# Fixing the List Config/Cycle Timer state machine race conditions

Re: Q-rev/D1.0 SA ballot comment I-22, 802.1 maintenance item 0319.  
Following up Alon Regev's work.

Mick Seaman  
mickseaman@gmail.com

# Net mgmt./List Config/Cycle Timer/List Execute configuration—current (1)

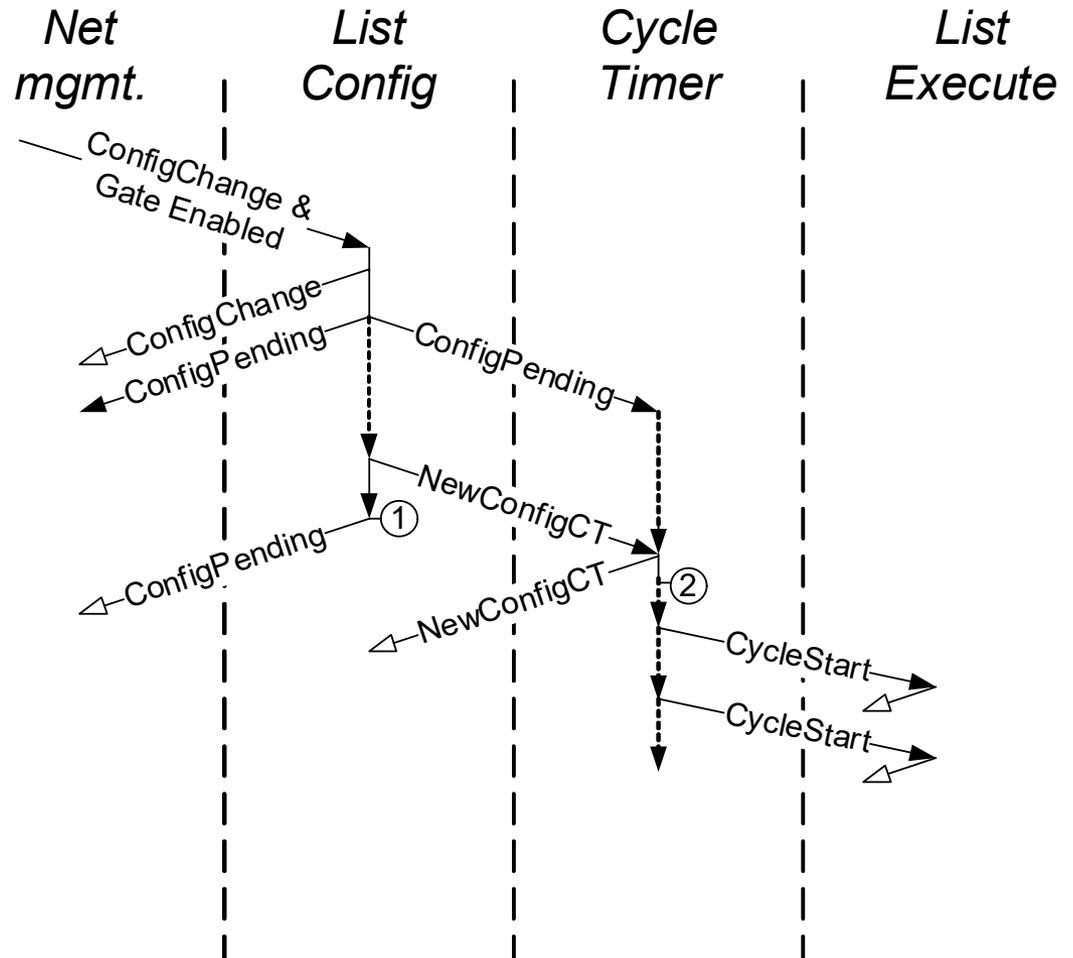
## Configuration change race

State machines do not constrain the execution order of List Config:UPDATE\_CONFIG and Cycle Timer:SET\_CYCLE\_START\_TIME, (1) and (2) in the Figure.

(1) clears ConfigPending, which affects setCycleTimer() processing at (2).

SetCycleStartTime() can be executed by toggling GateEnabled, so a change to clearing ConfigPending in the Cycle Timer machine needs to be conditional. Maintenance item 0319 proposes an extra state to clear the variable, but also clears it on one condition in the procedure.

# Net mgmt./List Config/Cycle Timer/List Execute configuration—current (2)

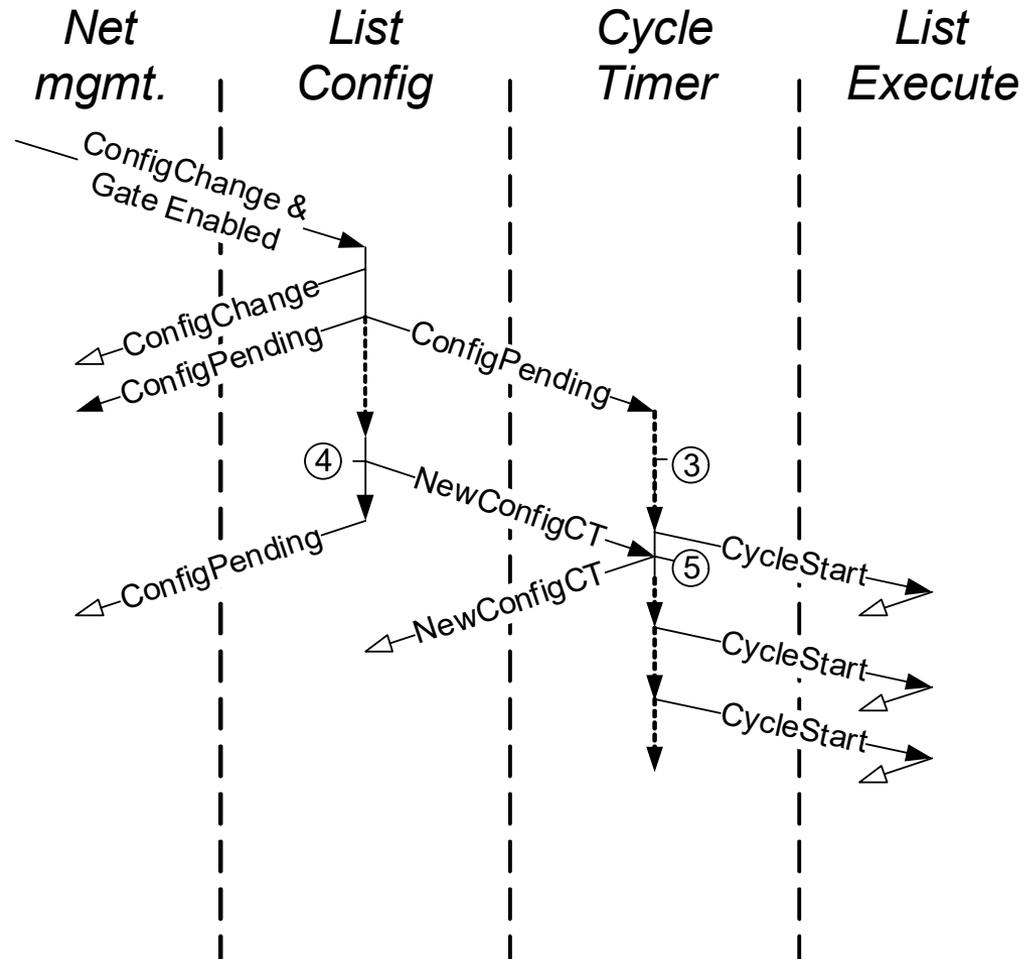
## Another race?

In the Cycle Timer machine, if ConfigPending and ConfigChangeTime is no later than CurrentTime + OperCycleTime + OperCycleTimeExtension then SetCycleStartTime case (d) delays the next CycleStartTime to ConfigChangeTime.

State List Config:UPDATE.. is entered when ConfigChangeTime <= CurrentTime and Cycle Timer:START\_CYCLE is entered when CycleStartTime <= CurrentTime, i.e. at the same time following case (d) above. Execution of the two states is mutually exclusive, but either can precede the other. List Execute:NEW\_CYCLE can be entered as soon as START\_CYCLE has executed, so can precede List Config:UPDATE.., and can take the first item from the old OperControlList before that list is updated.

# A better Cycle Timer machine (1)

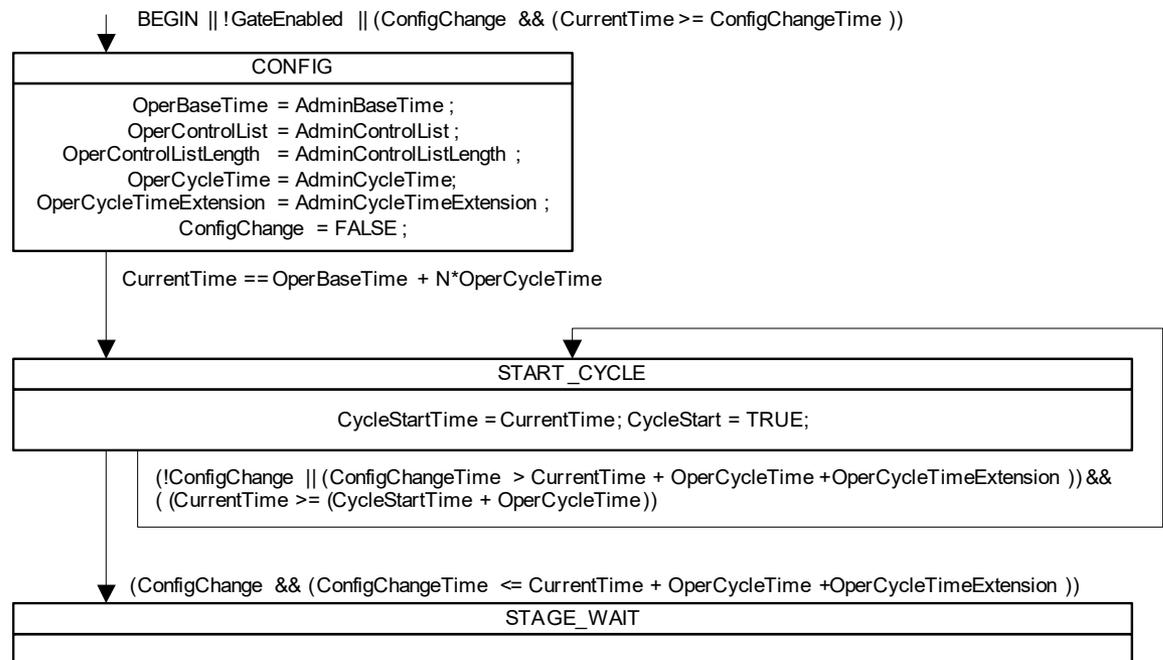
Don't use SetCycleStartTime() to test Config Pending and hide the significant state difference between:

- continuing an established set of cycles (with one set of Oper .. parameters)
- setting up a new, possibly delayed set of cycles with a new set of Oper.. parameters

Current curiosities:

1. Oper.. variables only set when GateEnabled, race condition on start up [removed].

2. Cycle start skipped when one more cycle would fit before ConfigChangeTime.

Don't split the logic for a new set of cycles between machines. Add update functionality to the Cycle Timer, make the update conditions explicit [no need for SetCycleStartTime()]. All List Config (if kept) has to do is calculate Config Change Time. List Execute machine unchanged.

Note: Open transitions take precedence, times are 'equal' if within implementation granularity, all eligible transitions occur before time advances.

# A better Cycle Timer machine (2)

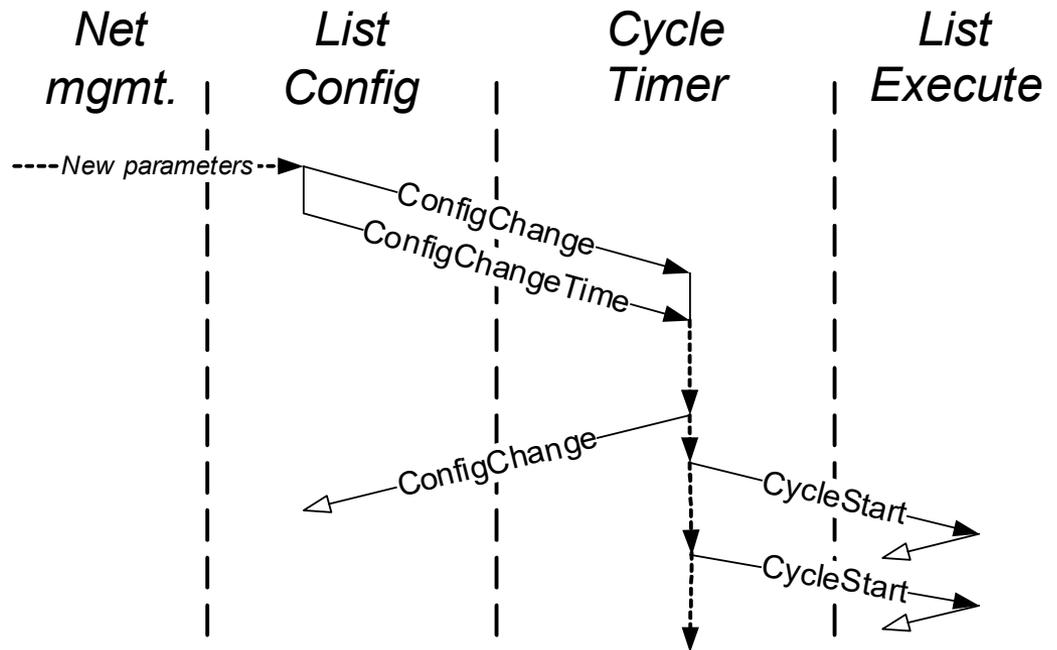
**But** there are a lot of references to ConfigPending in Q-Rev/D1.0, including throughout the management clauses. Need to be sensitive to current implementations and users, *sometimes fixing a mistake is a mistake.*

ConfigChange Time calculation, and ConfigChange set as a direct procedural result of a network management update of list parameters (no List Config machine required).

CycleTimer machine clears (resets) ConfigChange when the Oper.. variables have been updated with the new Admin variables [job done].

No need for ConfigPending or NewConfigCT.

# Proposed Cycle Timer machine

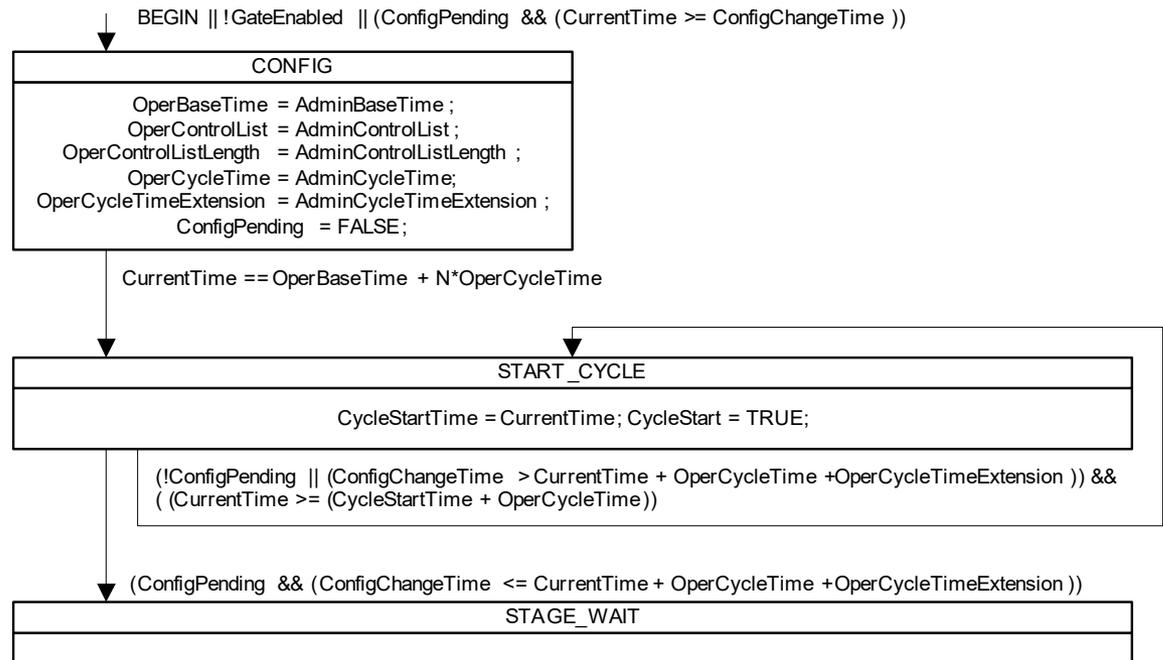
Curiosity left unchanged:

1. Cycle start skipped when one more cycle would fit before ConfigChangeTime.

As on Slide 6, but substituting ConfigPending for ConfigChange. SetCycleStartTime() procedure (8.6.9.1.1) no longer used, move Notes to 8.6.9.1. Trivial changes to 8.6.9.4.8, 8.6.9.4.12, and 8.6.9.4.21—refer to the state machine, not the procedure.

Note: Open transitions take precedence, times are 'equal' if within implementation granularity, all eligible transitions occur before time advances.

# Proposed List Config machine

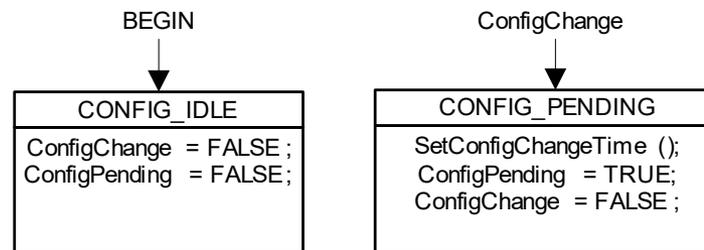
Curiosities:

1. Was not possible to configure the Oper.. variables before enabling Gates [removed]. This change has no effect on the use of gates when !GateEnabled since the List Execute machine will hold them in the AdminGatesState anyway.

2. ConfigChange not initialized by any machine [now shown as initialized by this machine].

Trivial accompanying changes to 8.6.9. pg 229 line 19, and through the subclauses of 8.6.9.4 (substitute Cycle Timer state machine for references to List Config state machine).
